**From:** "Suttora, Linda" <Linda.Suttora@em.doe.gov>  
**To:** "Xiaosong Yin" <XXY@nrc.gov>  
**Date:** 07/12/2006 3:49:32 PM  
**Subject:** Encapsulation Grout Pour\_7-11-061.pdf

## Volume of Encapsulation Grout Pour

The response to RAI 17 (Section RAI-17-B-2 in Appendix RAI-17-B) discussed volumes of grout to be used in calculating final waste form concentrations in the 300,000-gal TFF tanks. In that response the volumes of grout required for adequate encapsulation were  $85 \text{ m}^3$  for the engineered grout pours (initial encapsulation) and  $33 \text{ m}^3$  for the encapsulation pour. During discussions with the NRC on June 20, 2006, the NRC requested additional details regarding the methodology used to calculate the  $33 \text{ m}^3$  value. The following discussion provides the additional details.

Figure 2. Encapsulation grout pour locations.

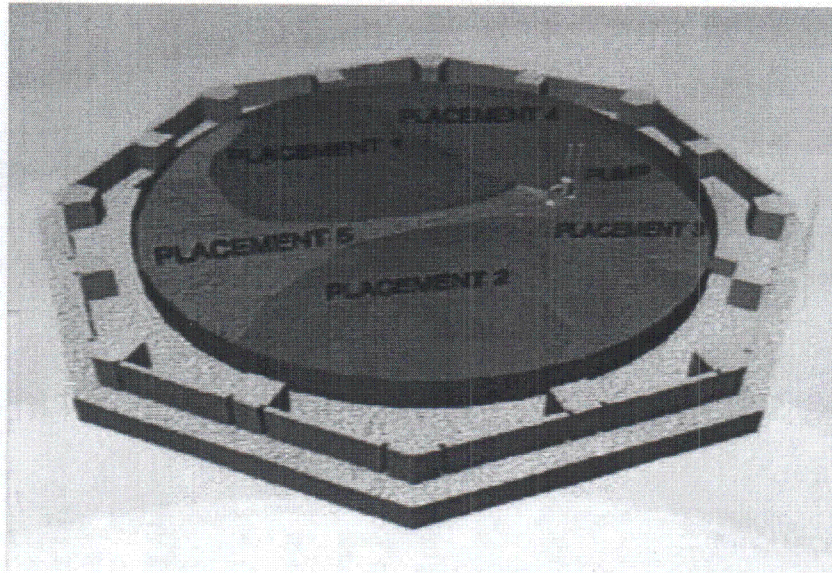
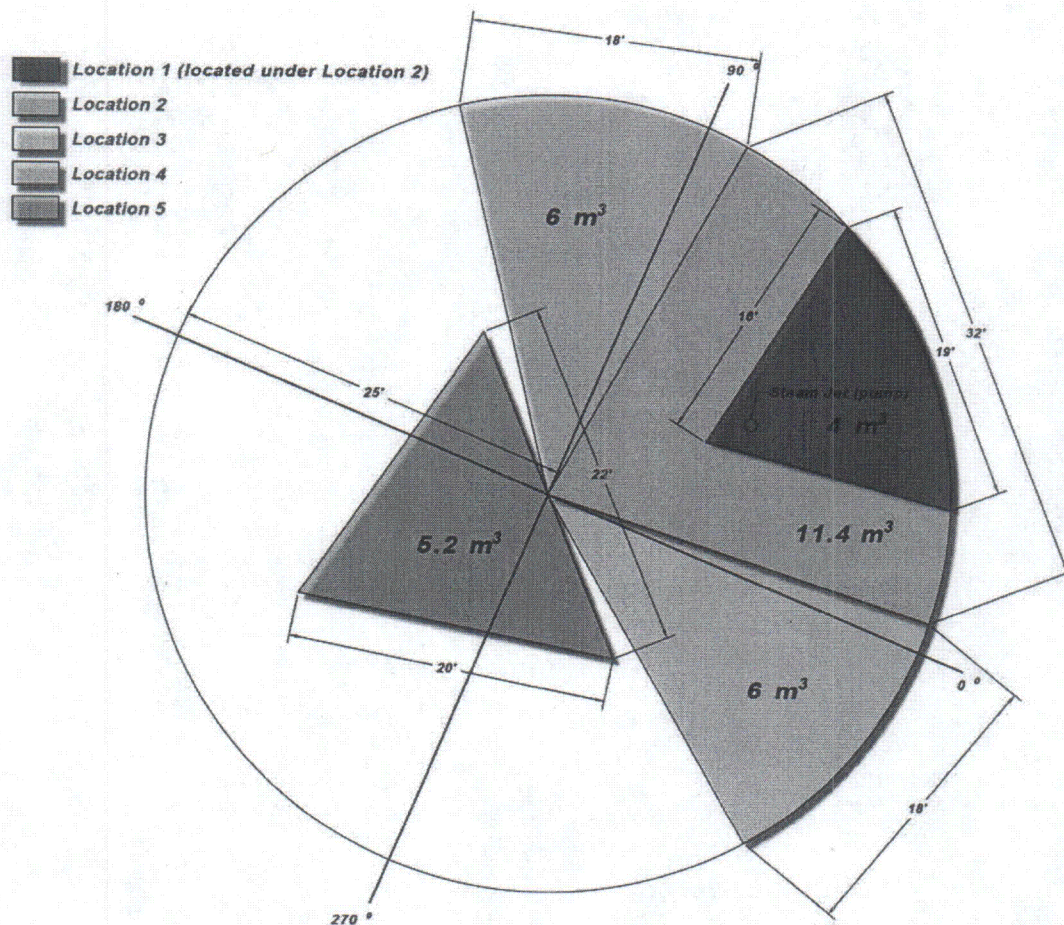
Please find the attached description of the volume of grout required for encapsulating residuals in the INTEC tanks. This is in response to questions raised during the NRC/DOE meeting in Idaho on June 20. I hope this answers any lingering questions as to the required volume of grout for encapsulation. Within a few days I should be able to send you the final information request from that meeting, specifically the modified inputs and outputs to the groundwater model questions. Please call me if you have any concerns.

The volume of the encapsulation grout pour in a 300,000-gal tank was determined by first reviewing photos of the grout mockup to observe the extent of surrogate staining after the engineered grout placements were completed. The depth of grout was estimated by reviewing photographs of the grout placement mockup. The areas without grout or with minimal grout were estimated after the engineered grout placements were poured. Additionally, areas that contained staining, showing the presence of surrogate materials, were also noted. The dimensions of the mockup tank are known (50 ft in diameter and 3.5 ft deep) and the areas and subsequent volumes without grout and those with residual staining were calculated. As stated in the response to NRC Comment 17, the encapsulation grout pour was calculated to be approximately  $33 \text{ m}^3$ . The total volume shown in Table 1 was rounded up to  $33 \text{ m}^3$  in the response.

The engineered grout placements are depicted in Figure 1 (below). The first two engineered grout placements create significant mounds and occupy approximately two-fifths of the tank bottom. The area near the steam jet (pump) contains no significant amount of grout after the engineered grout placement is complete. The encapsulation grout pour volume necessary to adequately encapsulate residual material at the engineered grout placement interfaces results in varying depths over the residuals. Simple geometric figures were used to calculate several location volumes. The depths of the locations considered ranged from 2 ft at the steam jet location to a minimum of 6 in. based on the slope of the engineered grout placements. Actual depths of encapsulation grout pours in the identified locations will likely range from well over a foot to 6 in. in depth to adequately encapsulate the residuals. To simplify these calculations, a 1-ft depth was assumed over the identified locations. The area around the steam jet is shown as Location 1 in Figure 2 (below). The volume ( $4 \text{ m}^3$ ) shown in Location 1 was calculated using 1 ft of grout to simplify calculations. The remaining grout around the jet was calculated as part of Location 2. Figure 2 shows the encapsulation grout pour locations as the simple geometric figures used to calculate area and volume.

Location 2 is the large area above the steam jet and includes the area surrounding the steam jet, which contains approximately 8 in. of grout as a result of the engineered grout placements. The depth of grout is known based on the height of the cooling coils in the tank bottom. The top of the cooling coils are 7 in. from the bottom. The cooling coils have been covered, as is evident in photographs in the response to NRC Comment 17, but streaks of surrogate material remain. To simplify the calculations, an average of 1 ft of grout is used to calculate the volume needed over Location 2 to ensure that all the waste materials have been covered. Location 2 has a calculated area of  $37 \text{ m}^2$  and volume of  $11.4 \text{ m}^3$ .

Location 3 (interface between Placements 2 and 3) and Location 4 (interface between Placements 1 and 4) are sections of the tank bottom that require additional grout because of the presence of surrogate on the surface and near the tank wall. These two locations have equal area and bound Location 2 on each side. An average of 1 ft of grout was used in the volume calculations over an area of  $21 \text{ m}^2$ . Locations 3 and 4 have a calculated volume of  $6 \text{ m}^3$  each.

Location 5 (interface between Placements 1, 2, and 5) is triangular shaped and covers the area where the various engineered grout placements converged. It is larger near the center of the tank and narrows as it moves from the steam jet location. The location covers 17 m<sup>2</sup> and the calculations used an average depth of 1 ft of grout resulting in a volume of 5.18 m<sup>3</sup>. As with Locations 3 and 4, the volume of grout is necessary to cover the surrogate waste materials on the surface of the engineered grout placements. Table 1 summarizes the volume and area of the encapsulation grout pour by location.
